Access Compliance Report

Public Rights-of-Way

(Pedestrian Signals)

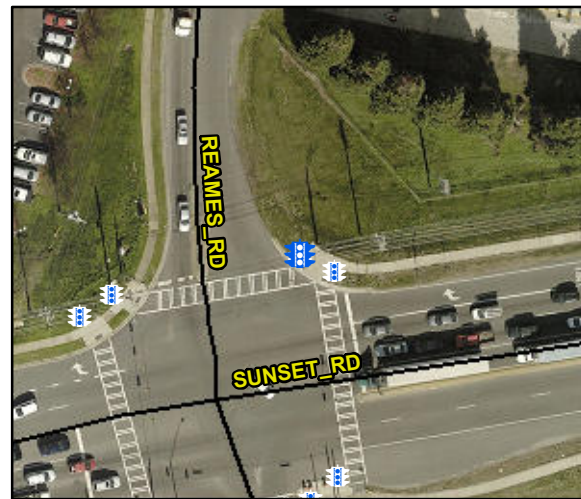
Intersection ID: N/A	Main Street:	Cross Street: N/A	Location: N/A
ADA ID: E8B217A4224D	Signal Type: One Push Button-APS	Overall Compliance: No	Severity Score: BTN 1: N/A BTN 2: N/A No BTN: N/A
Codes/Mitigation Info/Possible Solution		Field Measurements/Component Compliance

PROW/ADA: R404.2, R404.3, R404.7.3,
R404.7.2, R209.1, MUTCD 4e.10

Possible Solutions: Remove & Replace
Replace APS Button With New APS Button.
Remove and Replace Clear Space.
